Submissions Report

Proposed Bulk Fuel Storage Facility, Mayfield NSW

20 April 2012

Figure Error! No text of specified style in document.-1: Difference in Max and Min Temperatures between NSW and San Francisco

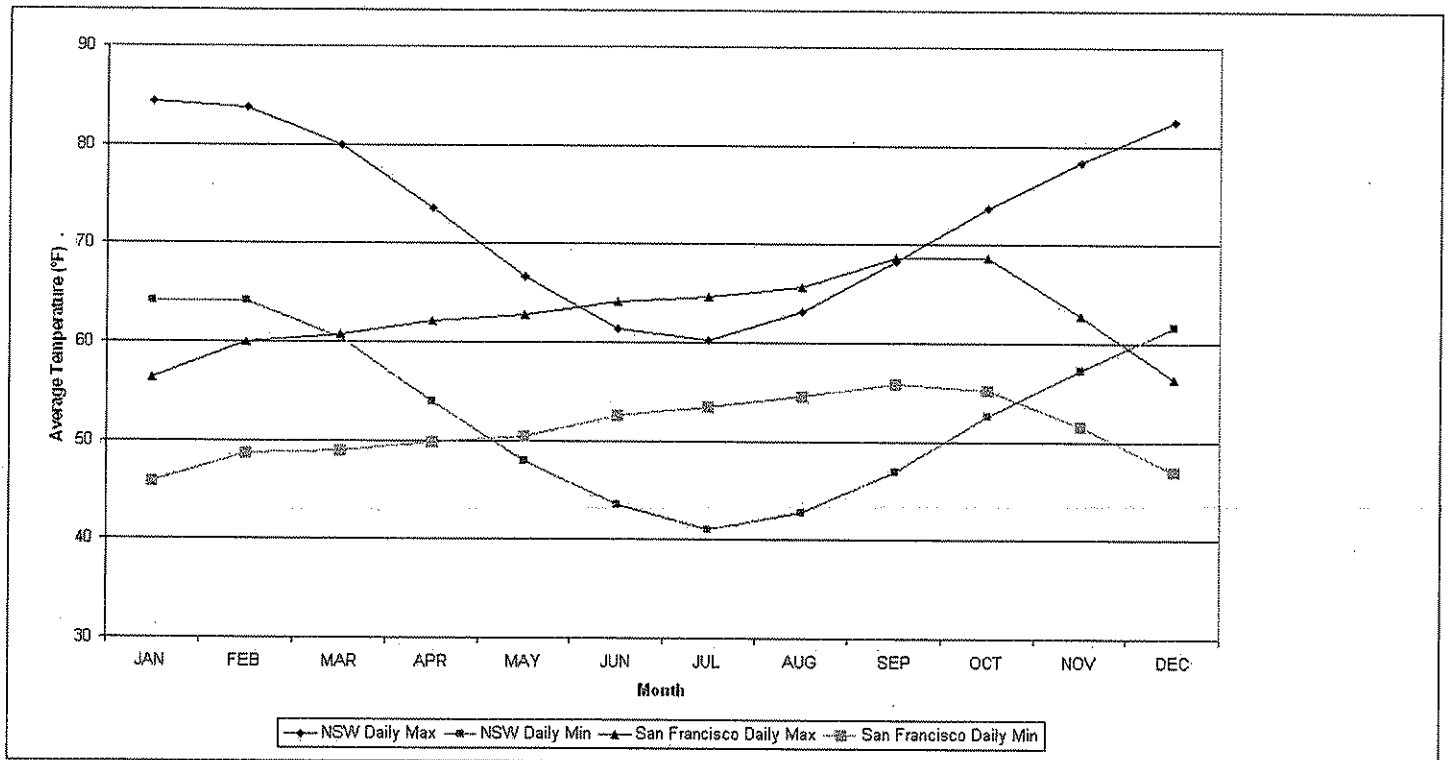
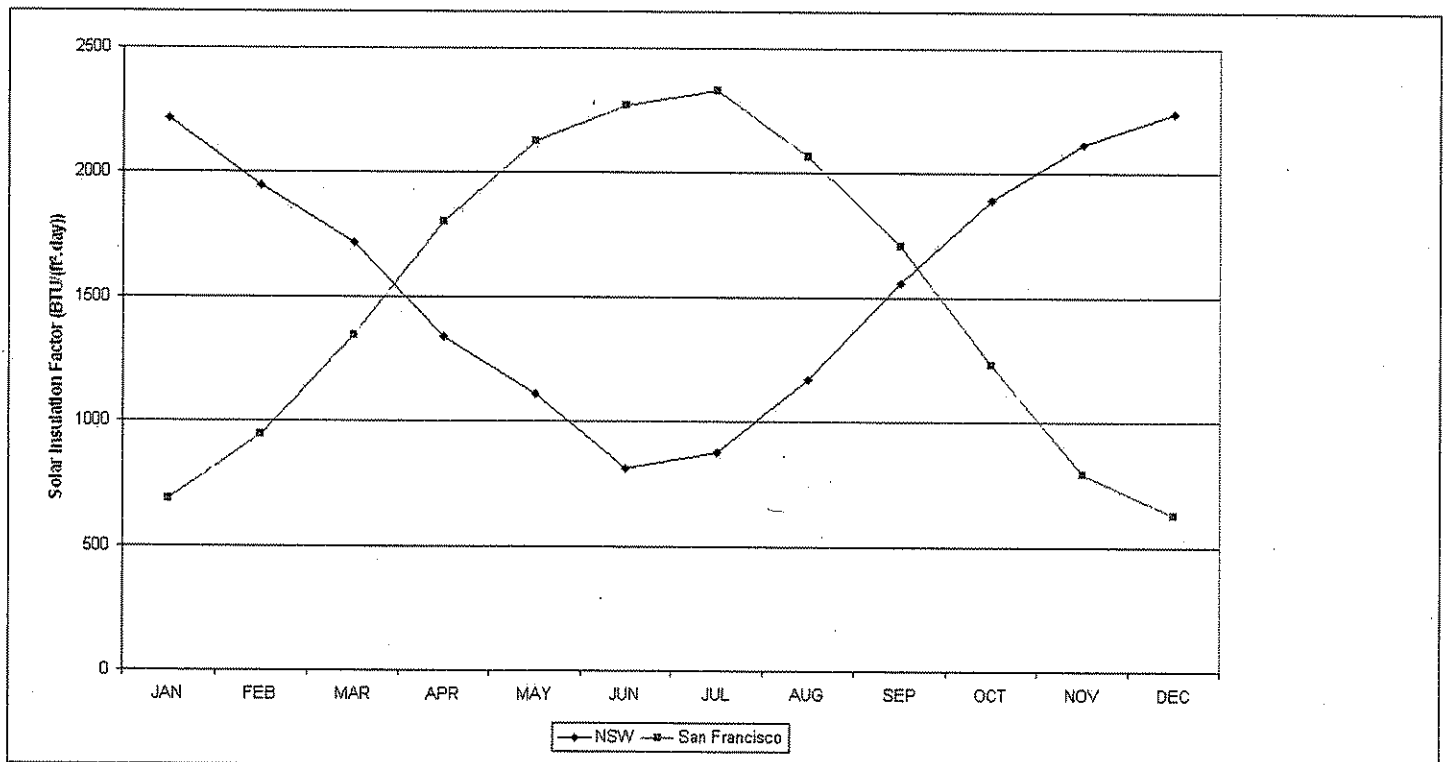
The EPA notes that the meteorological data used in the assessment is the default data set shipped with the software program for San Francisco. This is significantly different meteorological conditions to those expected at the proposed site.

The EPA has performed a comparison of meteorological conditions that should have been used in the assessment from those of San Francisco. The difference in monthly maximum and minimum temperature between NSW and San Francisco is presented in Figure Error! No text of specified style in document.-1.

The difference in solar insolation factors between NSW and San Francisco is presented in Figure Error! No text of specified style in document.-2.

The EPA notes that wind speed is also used in estimated emissions by the TANKs program. However, this information is not presented in the Environmental Assessment's Air Quality Impact Assessment ("AQIA"). It is assumed that San Francisco average wind speed was used in developing the emission estimates. By using San Francisco meteorological data, maximum emissions from the proposed tanks have been estimated to occur during winter and minimum emission have been estimated to occur in summer. This is the opposite of what would occur. However, as the emissions are from a low volatility liquid, the majority of emissions are from working loss and not from breathing loss.

No.	Issue	Response	Reference
	<p>program. However, this information is not presented in the AQIA. It is assumed that San Francisco average wind speed was used in developing the emission estimates. By using San Francisco meteorological data, maximum emissions from the proposed tanks have been estimated to occur during winter and minimum emission have been estimated to occur in summer. This is the opposite of what would occur. However, as the emissions are from a low volatility liquid, the majority of emissions are from working loss and not from breathing loss. Using the incorrect meteorological data in TANKS has resulted in incorrect emissions being estimated for the air quality assessment. The EPA recommends that site specific meteorological data is used to assess the impacts of the proposed facility in a revised air quality assessment.</p>	<p>resulted from those thermal properties, therefore, were not incorrect. Newcastle wind data are used in the AQIA.</p>

Figure 1 Site and Sensitive Receptor Locations
Marstel Terminals Newcastle Pty Limited
Air Quality Impact Assessment
Mayfield NSW

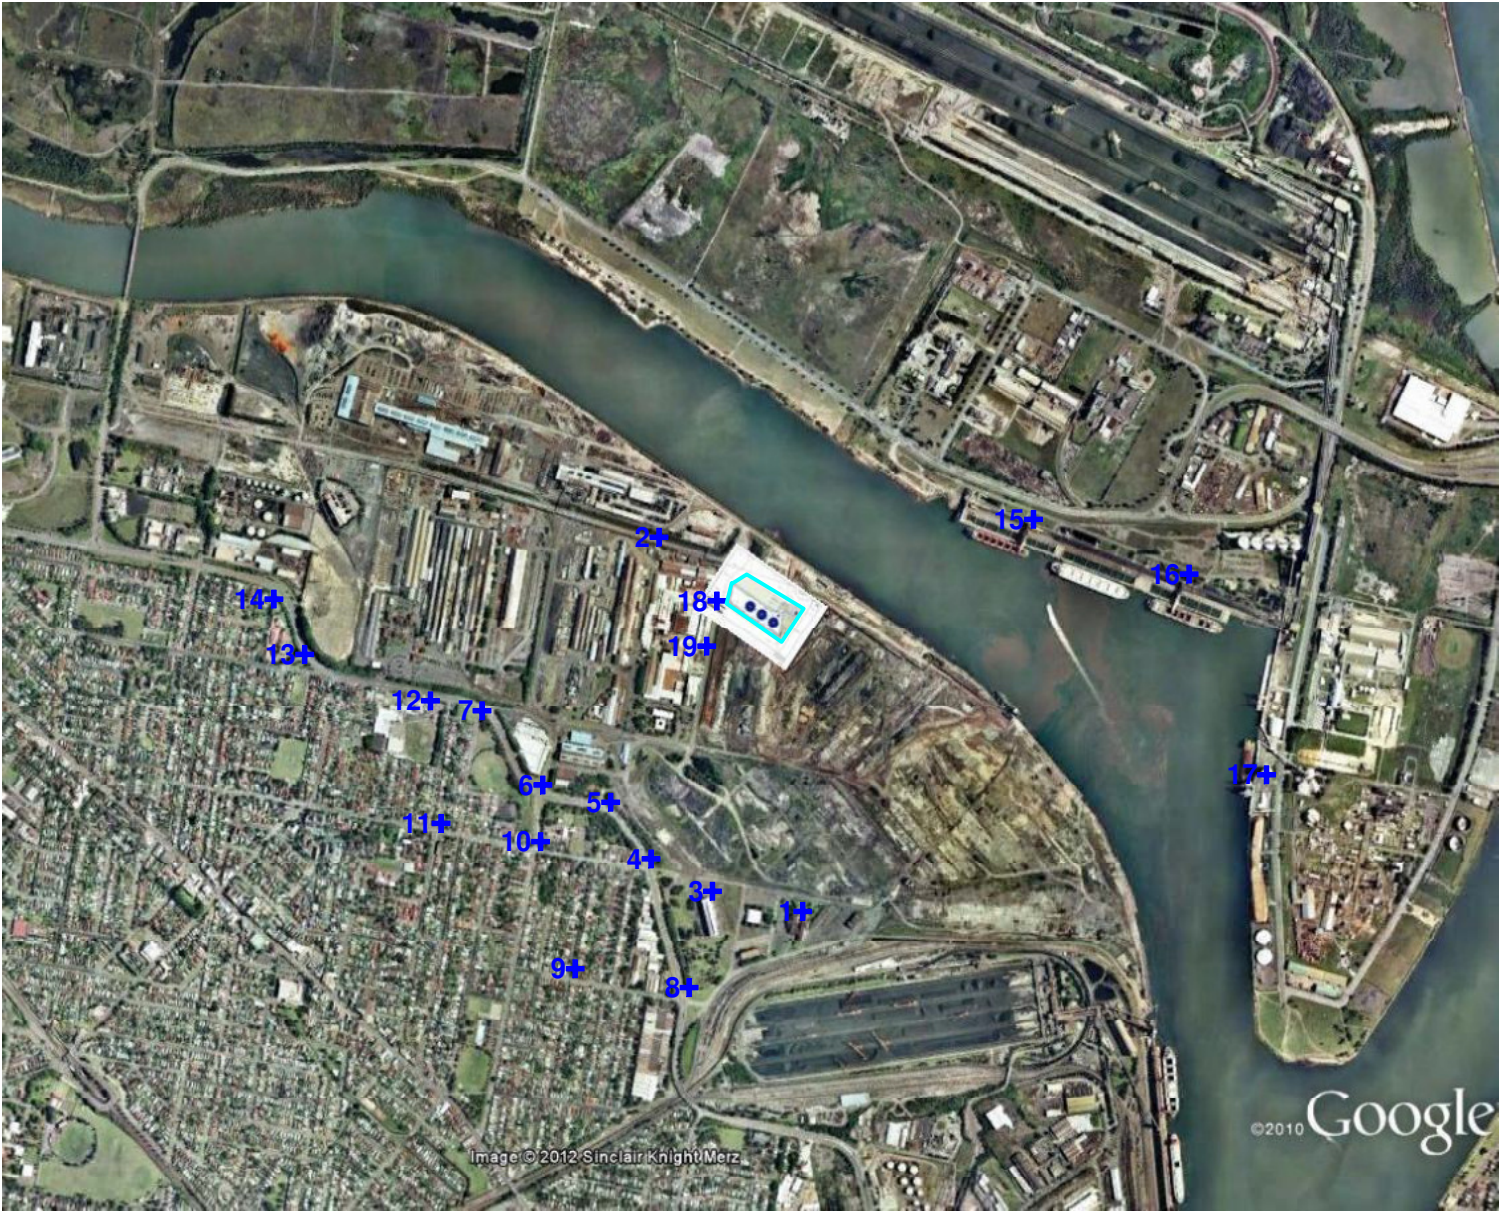
OneSteel was unable to verify the air quality assessment in the application as it does not provide the referenced Figure (Figure 1 in Appendix F) showing the "sensitive" locations of the modelled ground level benzene concentrations. The nearest receptor (G2 at the Wire Mill) does not appear to have been considered as a worst case based on the table describing the locations (Table 9 lists George Bishop Drive but not a precise location). OneSteel requests the proponent confirm that the GLC's of benzene at G2 will present no unacceptable health risk to OneSteel employees.

Air Quality / Odour			
85	OneSteel was unable to verify the air quality assessment in the application as it does not provide the referenced Figure (Figure 1 in Appendix F) showing the "sensitive" locations of the modelled ground level benzene concentrations. The nearest receptor (G2 at the Wire Mill) does not appear to	The figures were erroneously omitted from the AQIA. The figures indicated that predicted levels of benzene were below the OEH criterion level at the OneSteel premises. Following the receipt of further information from OEH. Cumene has	Refer to Appendix C .
